**Re: ODOARDI – Vacant Lot  
22 Nethermont Ave. – New House Construction  
Tax ID: Section 122.16 – Block 4 – Lot 7**

G.E.S Revisions/Written Response to Comments addressing the comments received 03/18/2021

G.E.S Revisions/Written Response to Comments addressing the Planning Board Staff Report, dated January 24, 2020, and Revisions/Written Response to Comments Received from Kellard Sessions (Town Consulting Engineer), dated January 24, 2020.

SCALE: 1" = 10'  
 DATE: JANUARY 10, 2020  
 DRAWN BY: GC CHECKED BY: ES.  
 LS-1  
 SHEET 4 of 5

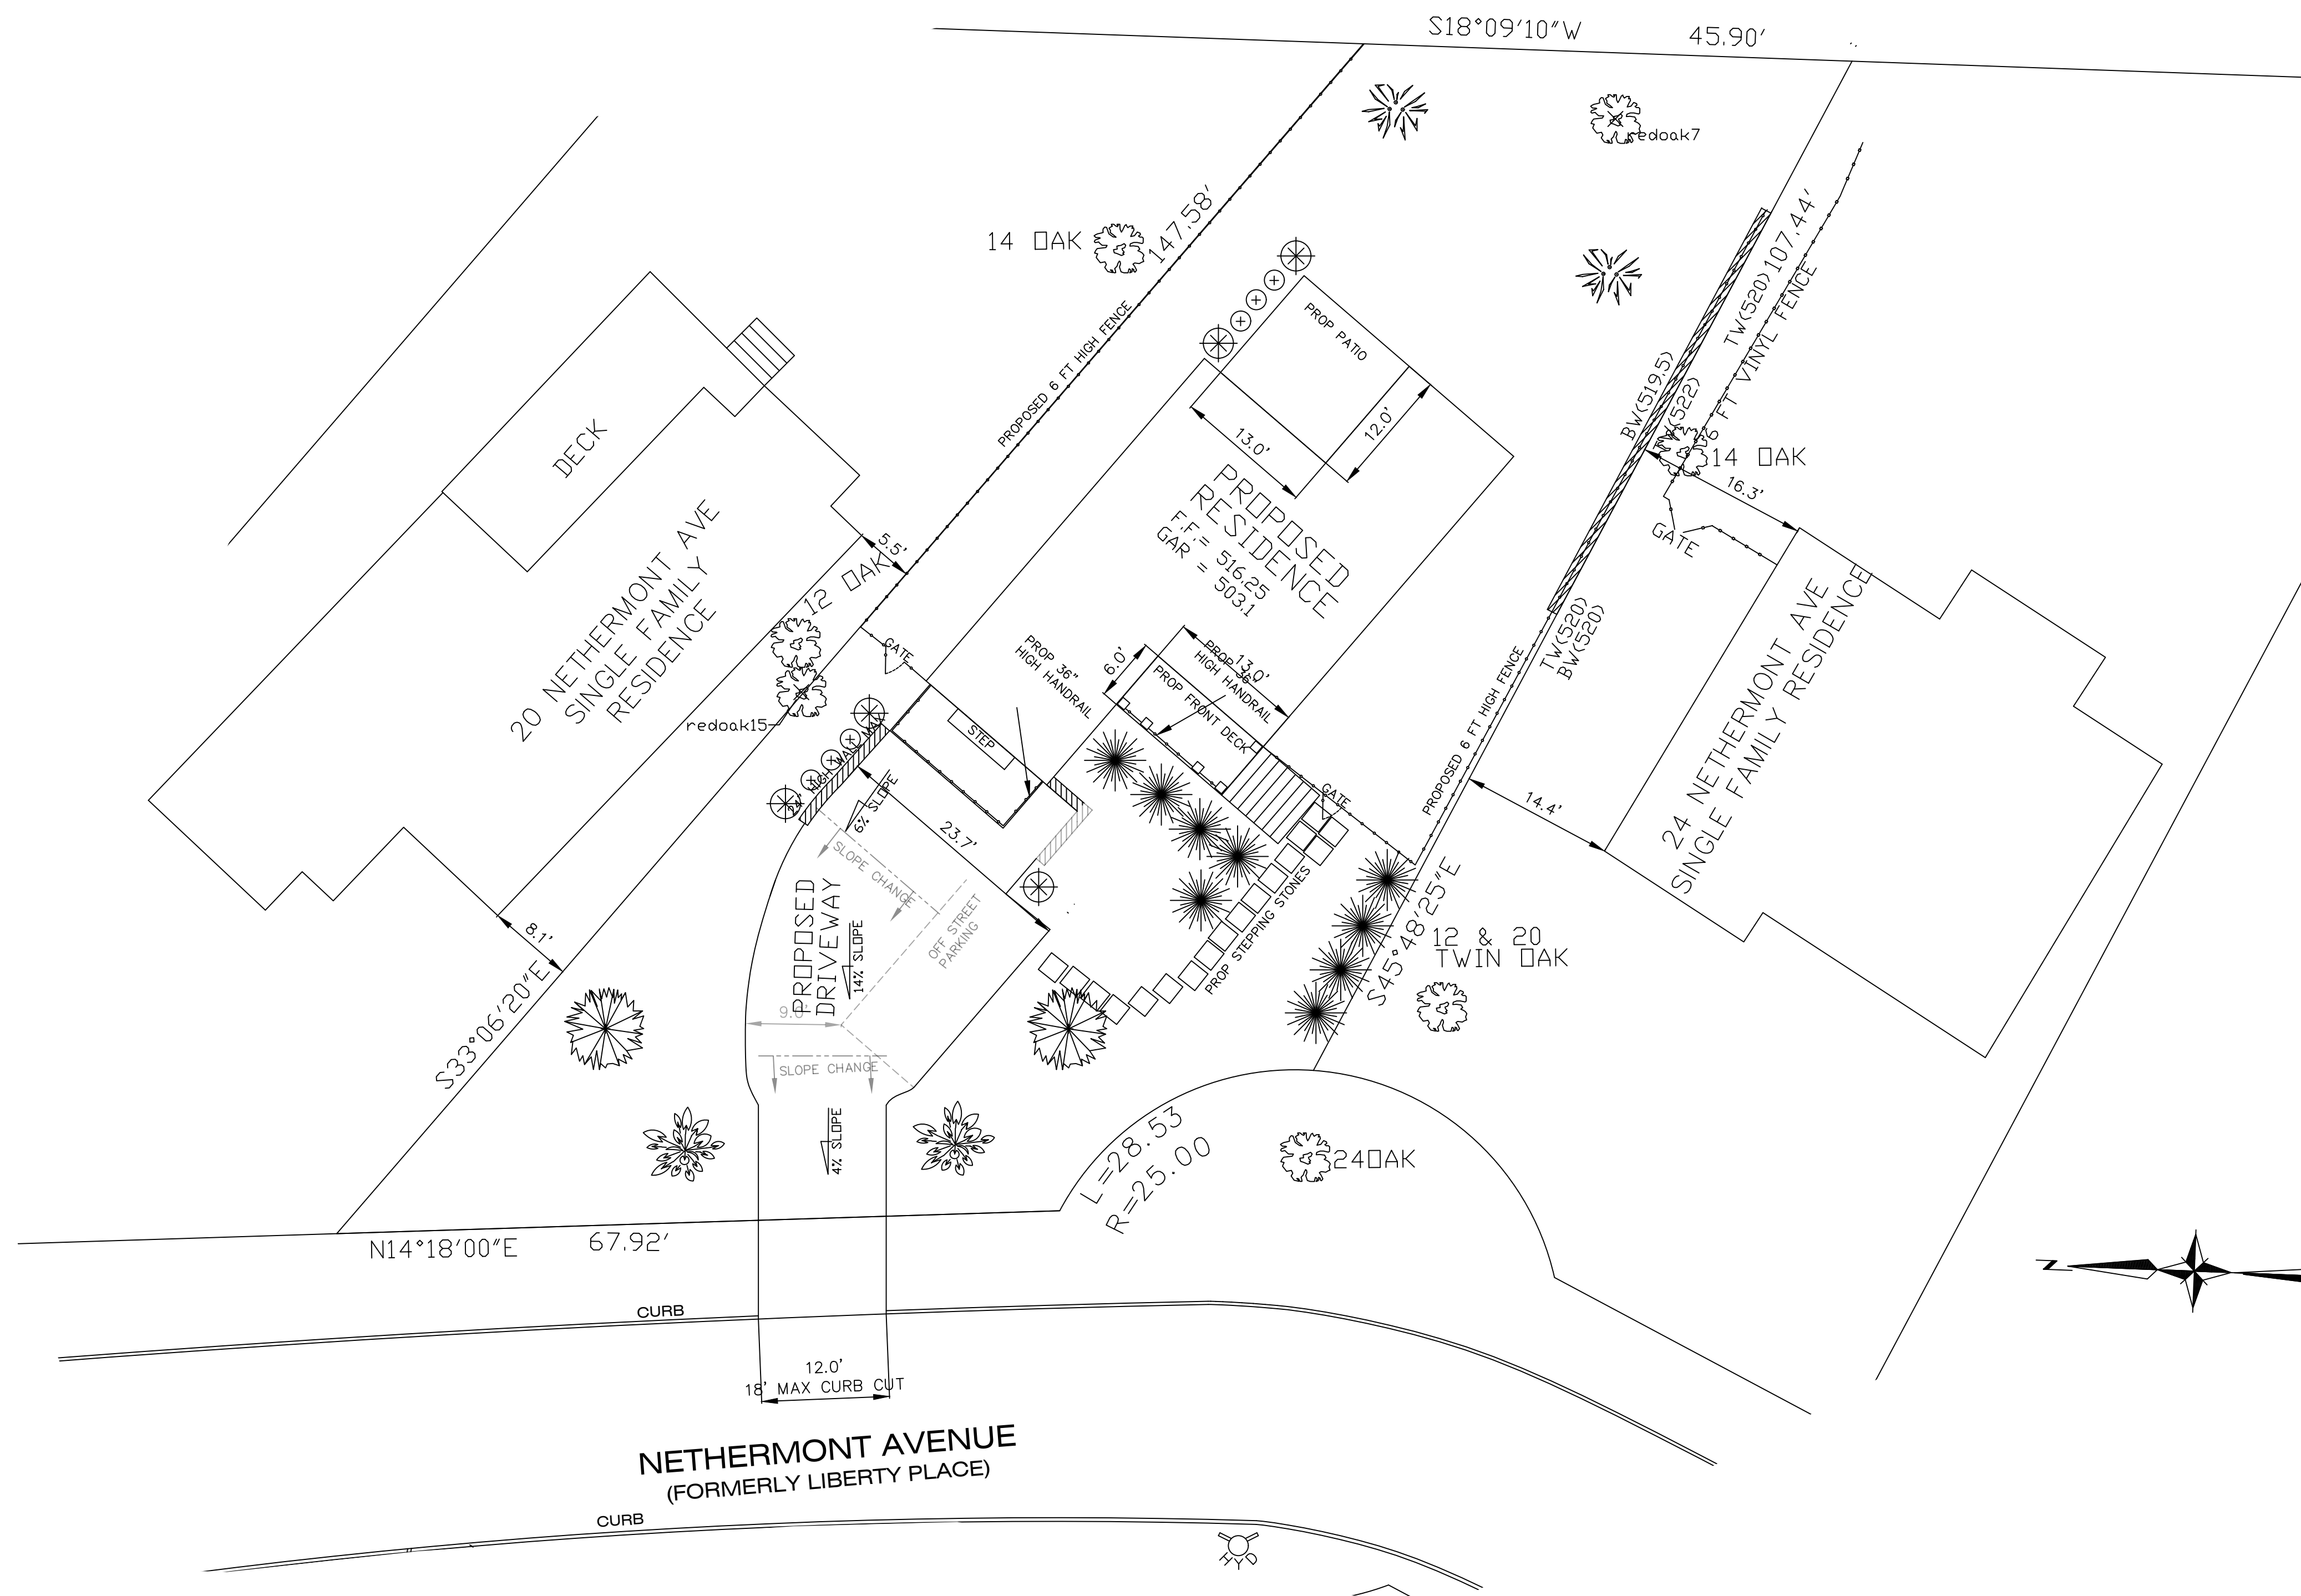
- All walls in excess of 6 ft have been removed.
6. The site plan depicts the removal of 12 (all but one) Town-regulated trees. *(Staff Notes: Pursuant to Section 308-15 of the Town Code the Applicant should submit a tree survey indicating the size, species and condition of the trees on the property. In addition, the Applicant should provide a plan that details the replacement proposed to mitigate the impacts from the proposed tree removal. It is recommended that additional planting be provided along the side lot lines.)*

- A tree survey (Sheet TS-1), arborist table/letter (Table on sheet TS-1 and Letter Included in Submittal), and replacement tree plantings (Sheet LS-1) have all been provided.
